## **STAFF COMMENTS FOR PLANNING COMMISSION**

**SITE PLAN: SP-06-0002**

**TITLE: CRISWELL USED CARS**

**REQUEST: PRELIMINARY/FINAL PLAN APPROVAL**  
18,363 Square Foot Car Dealership Building

LANDSCAPE PLAN & LIGHTING  
PARCEL "A"  
**BAILEY PROPERTY**  
CRISWELL USED CARS

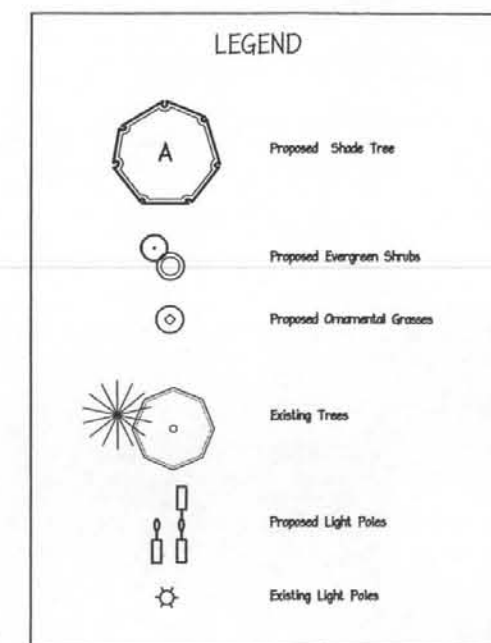
In reviewing the Landscape Plans (Exhibits 10-12), staff recommends that the applicant not limit the grass type or the junipers to one variety and that a mulch bed be specified for the holly bushes and the trees. The applicant will be providing a fee-in-lieu for afforestation requirements (see condition below).

1. Applicant is to submit a detail of the masonry dumpster enclosure in accordance with Section 24-220(h) for review and approval by staff;
2. Applicant is to revise the landscape plan to add a variety of plant types and mulch beds for the holly bushes and trees;
3. Final storm water management, lighting, and photometric plans are to be approved by Department of Public Works, Park Maintenance and Engineering (DPWPM&E) prior to the issuance of site work permits;

LIGHTING PHOTOMETRIC PLAN  
PARCEL "A"

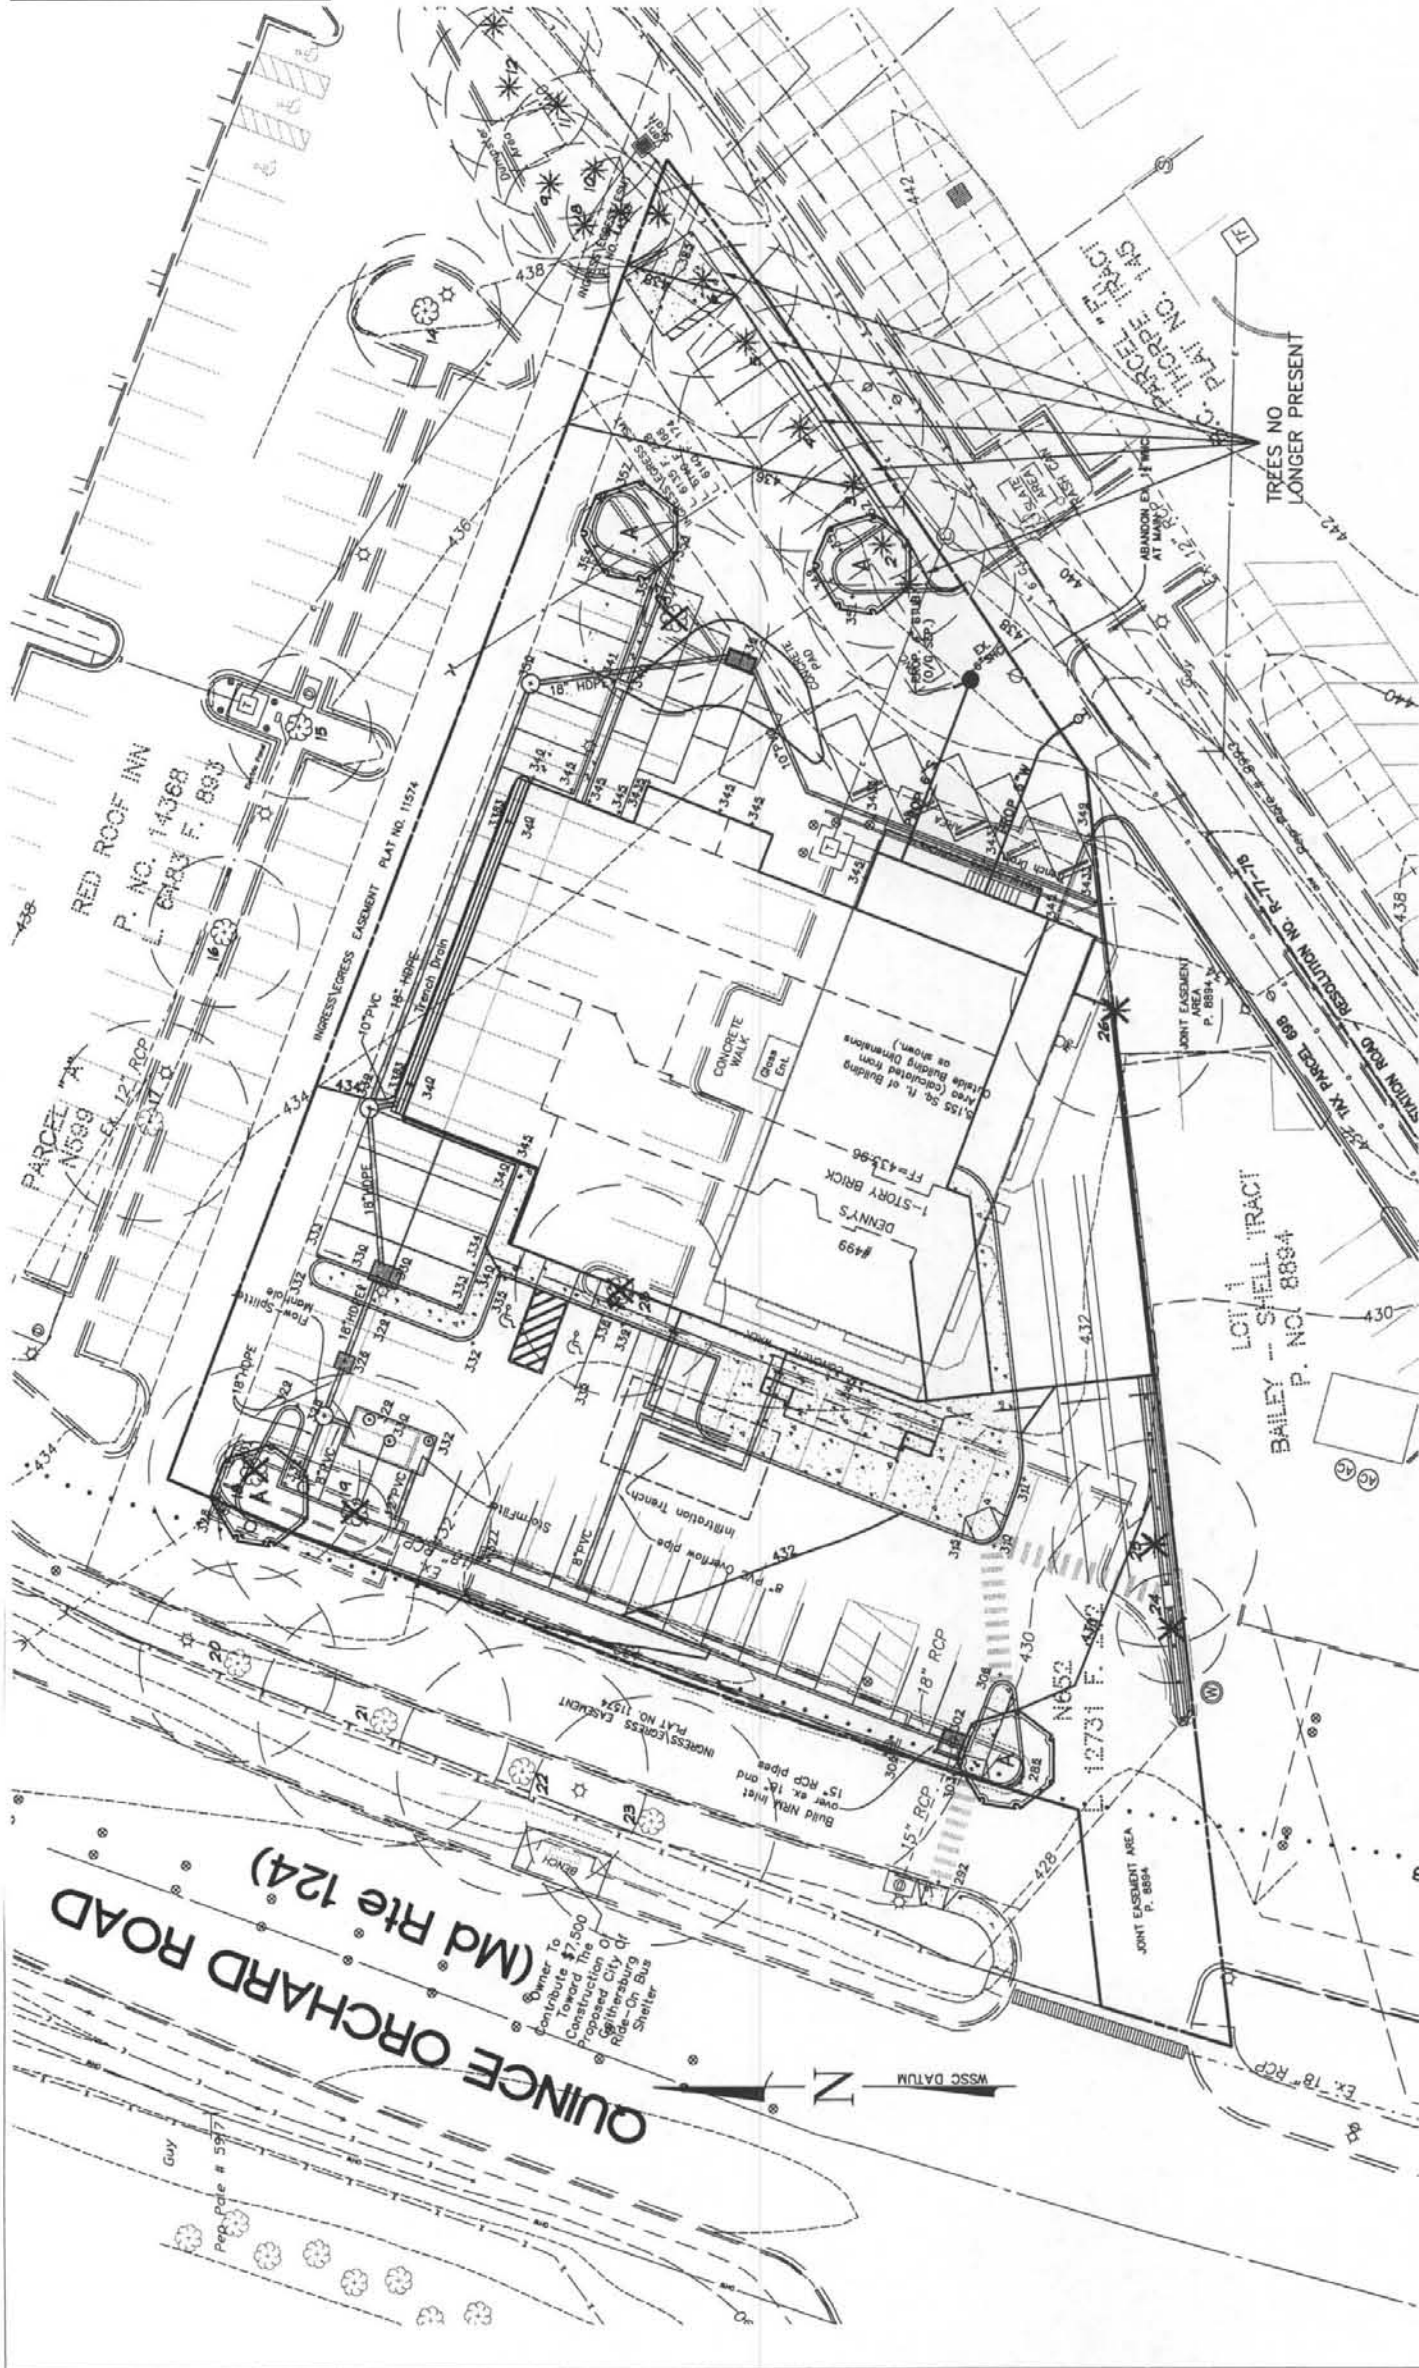
The applicant has been working with the Department of Public Works, Park maintenance and Engineering (DPWPM&E) on their stormwater management plans and the lighting and photometric plans. DPWPM&E would request the Commission to condition the approval of the plan subject to their approval, as these plans need a few "tweaks."

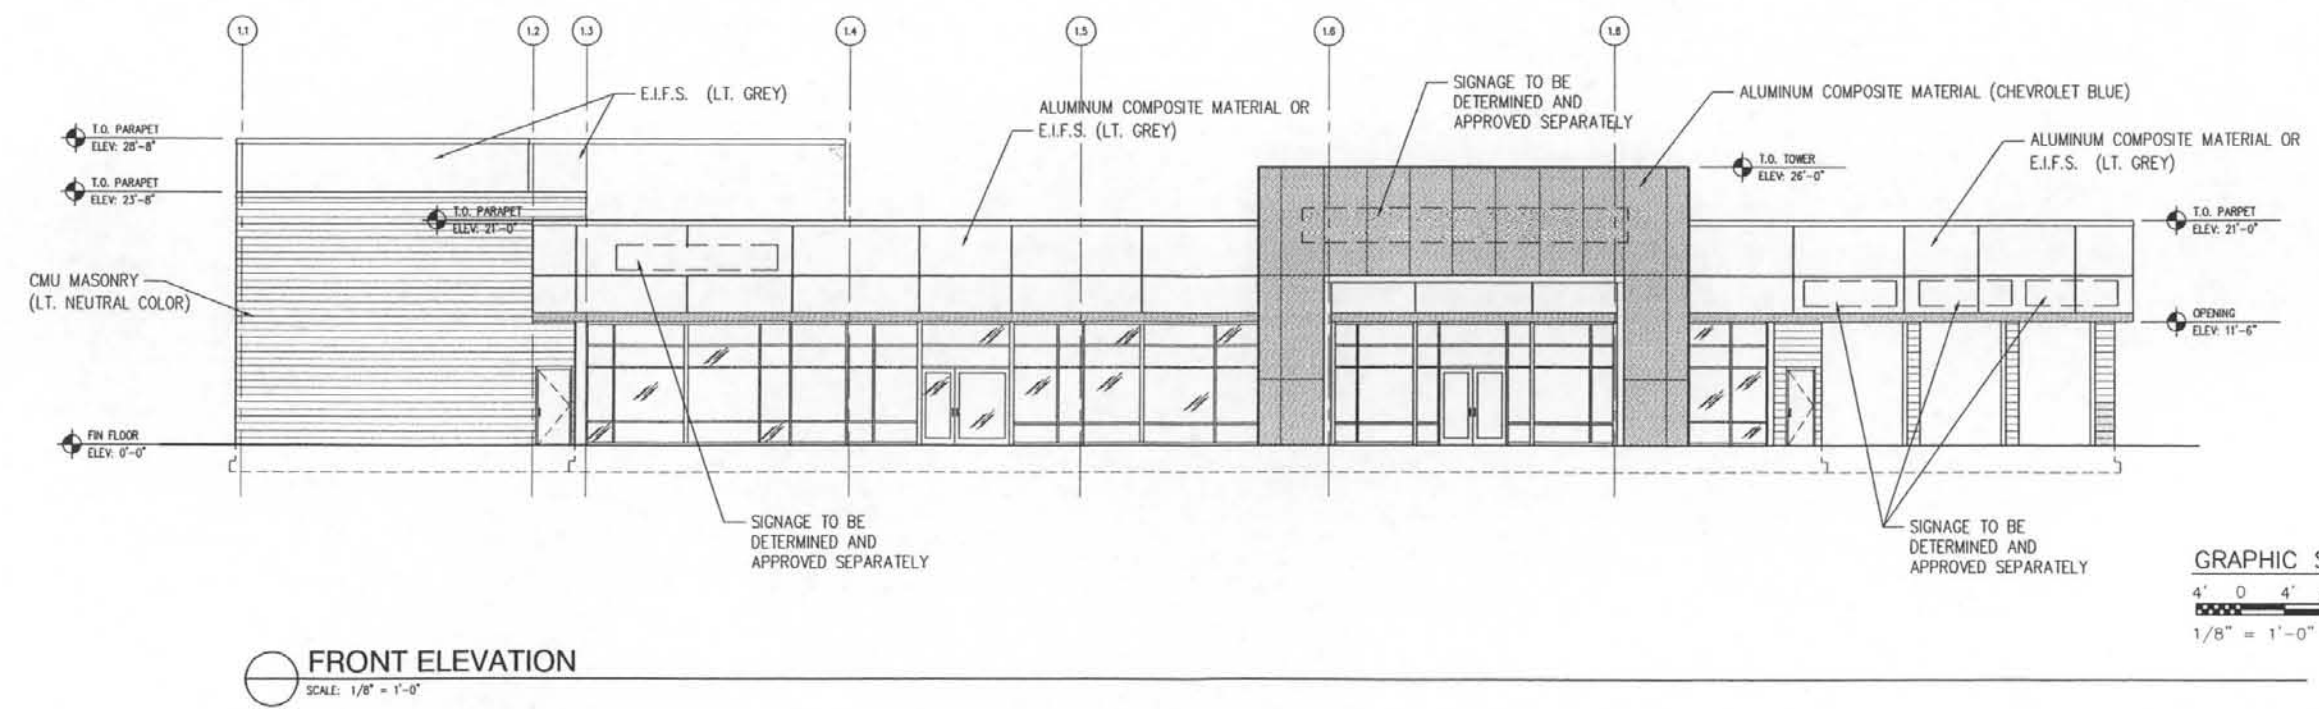
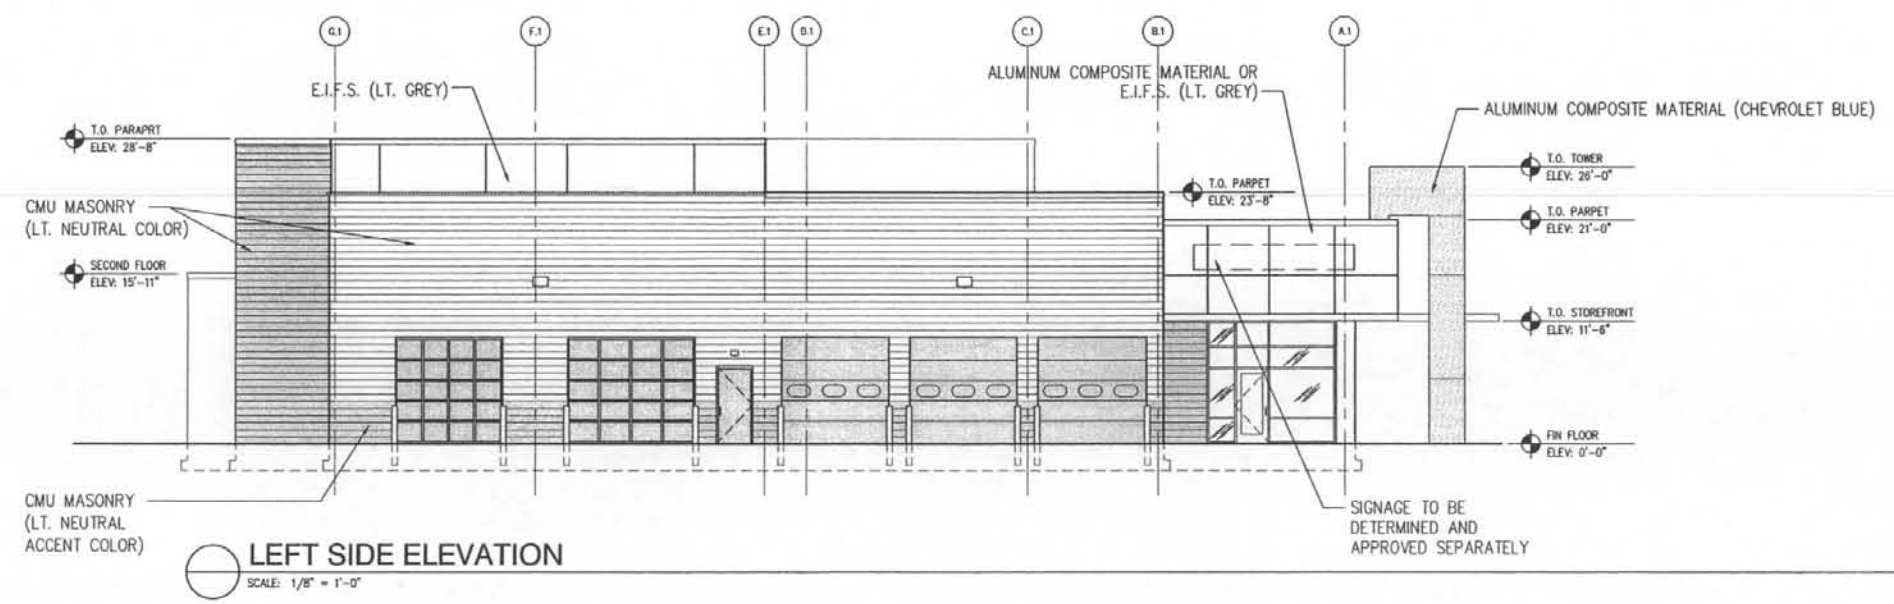
The architecture of the building has changed slightly since the presentation at the Concept Site Plan. (See Exhibits 16-17.) The building materials consist of EIFS (light grey), glass storefront, aluminum composite material (Chevrolet Blue), and Concrete Masonry Unit (CMU) – two different neutral shades. At the concept review, the applicant stated that the CMU would be split-faced block. Staff has requested the applicant's architect to bring in samples of the CMU. (An example of this type of block would be the Best Buy store or the Rosenthal car dealership.)

There is also a note concerning the dumpster enclosure, which is located on the northeast corner of the site, on the architectural plan. The dumpster enclosure is required by Section 24-220(h). Originally, the applicant had submitted a wooden fence enclosure and staff requested an enclosure to match the building materials. Since there is no detail shown, staff would recommend a condition that the applicant submit a detail on the signature set of site plans and elevations to be approved by staff.
